<b>Model</b>	AD3 Finisher	<b>Volt/Hz</b>	<b>Date of Modification</b>	<b>Serial Number</b>
<b>Modified Article</b>	Parts Catalog			
<b>Reason for Modification</b>	Parts Catalog Correction

Model: Finisher for AD3		Date: 30-Apr-97	No: 3
Modified Article: Lower Cover		Prepared by: E.Fukuyama	
From: QAC 2nd Field Information Dept.		Checked by: S. Fujii	
Reason for Modification:	<input checked="" type="checkbox"/> Parts catalog correction	<input type="checkbox"/> Vendor change	<input type="checkbox"/> To meet standards
	<input type="checkbox"/> To facilitate assembly	<input type="checkbox"/> To improve reliability	( )
	<input type="checkbox"/> Part standardization	<input type="checkbox"/> Other

Model: Finisher for AD3		Date: 15-Jun-97	No: 5
Modified Article: Positioning Fence Mylar		Prepared by: E. Fukuyama	
From: QAC 2nd Field Information Dept.			
Reason for Modification:	<input type="checkbox"/> Parts catalog correction	<input type="checkbox"/> Vendor change	<input type="checkbox"/> To meet standards
	<input type="checkbox"/> To facilitate assembly	<input checked="" type="checkbox"/> To improve reliability	( )
	<input type="checkbox"/> Part standardization	<input type="checkbox"/> Ot

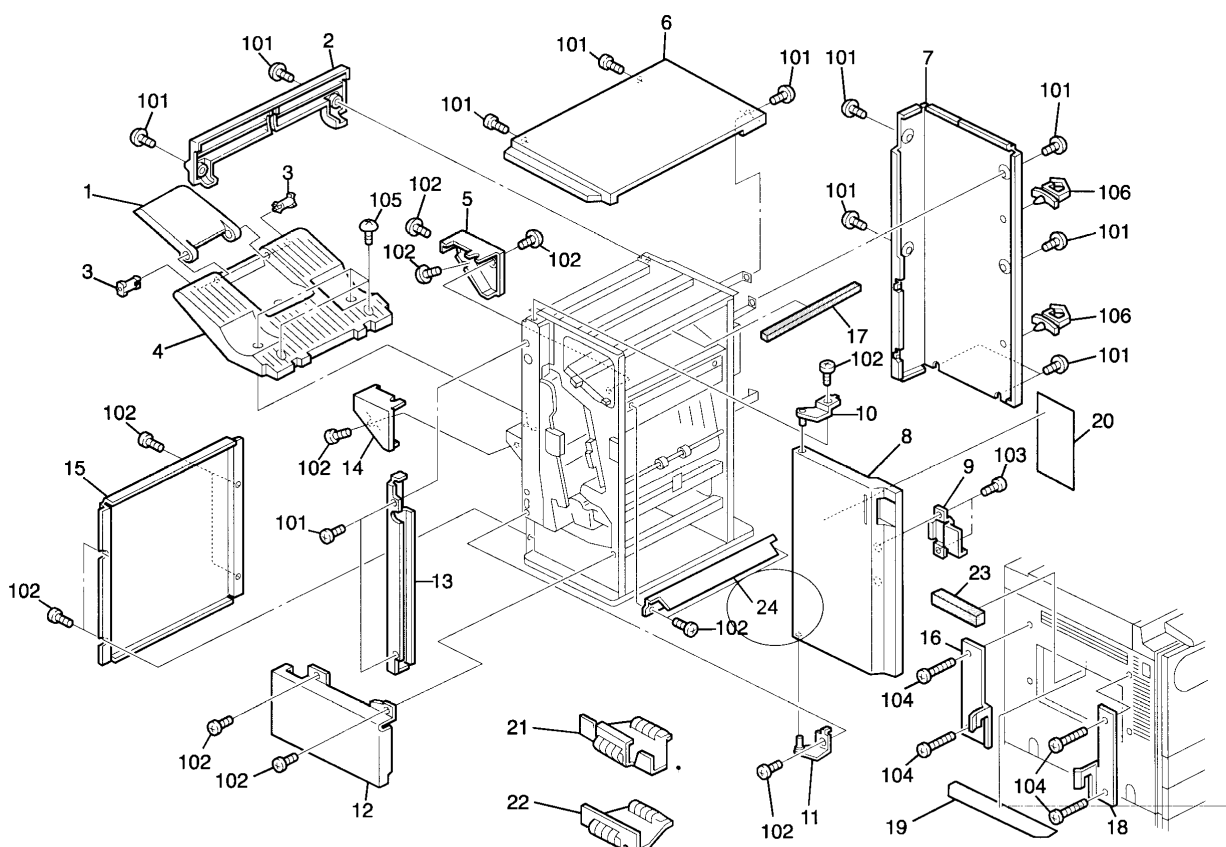
The following should be corrected. Please correct your part catalog.

Old part number	New part number	Description	Qty	Index	Page
	A6122412	Entrance Guide Plate	1	24	7
A6124140		Lower Cover	1	12	7
	A6126179	Lower Front Cover	1	12	7

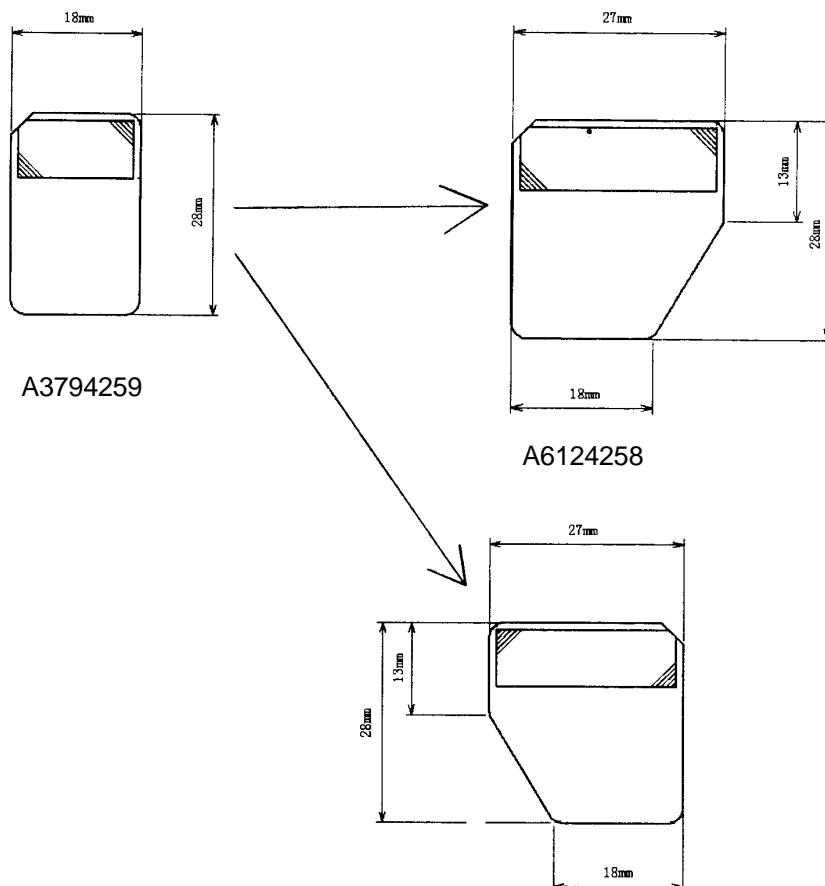
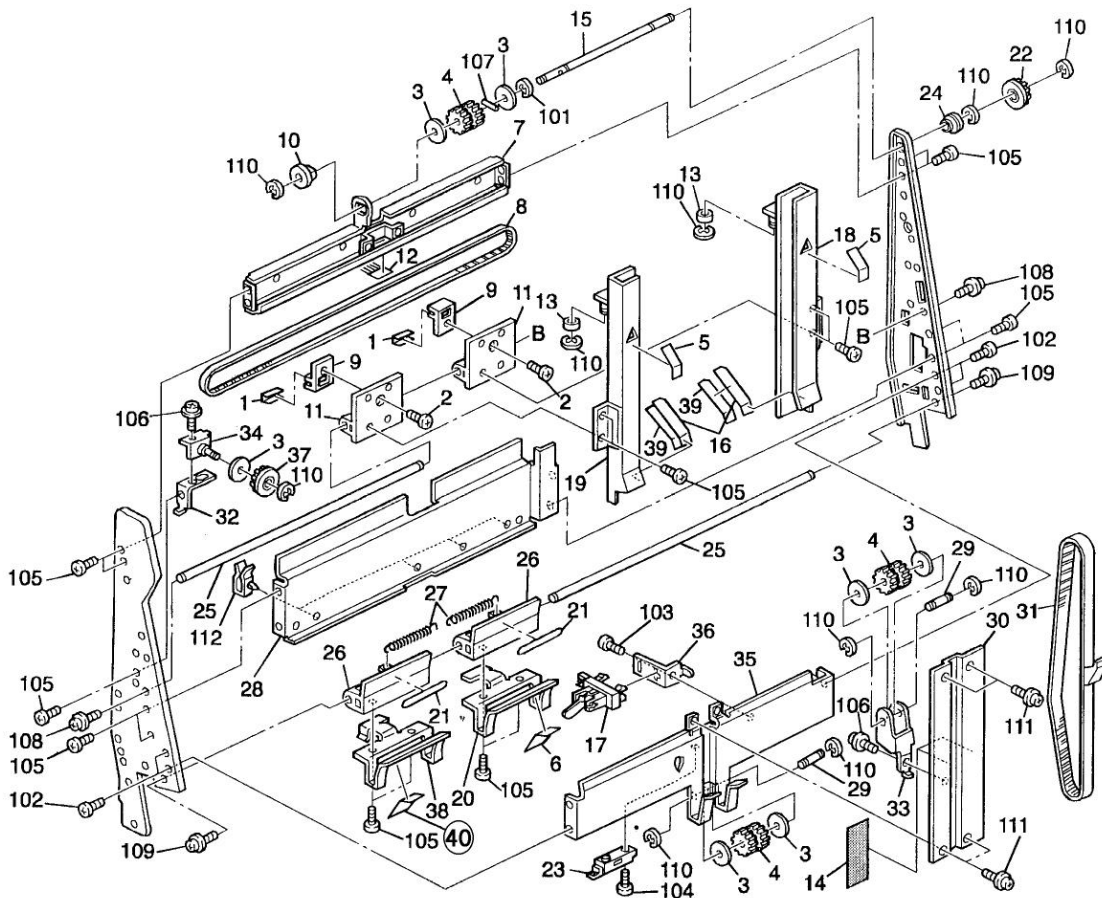
To improve paper stacking reliability, the shape of the mylar on the Positioning Fence has been changed.

Old part number	New part Number	Description	Qty	Int	Page	Index	Note
A3794259	A6124258	Positioning Fence Mylar : Rear	1	X/O	13	6	
A3794259	A6124259	Positioning Fence Mylar : Front	1	X/O	13	40

Old Entrance Guide

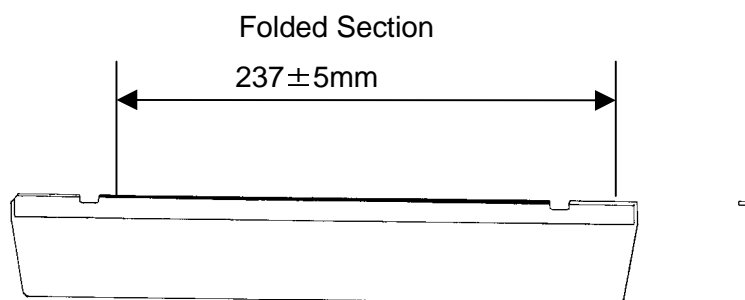
We would like to inform you of the modification to the shape of the Entrance Guide packed with the Finisher.

The Entrance Guide bends easily, so it is difficult to install on the Main Frame.

To increase the strength of the Entrance Guide (mylar), the edges have been folded.

Old Part Number	New Part Number	Description	Qty	Int	Page	Index	Note
<b><i>A6122331</i></b>	A6122333	Entrance Guide	1	X/O	7	19
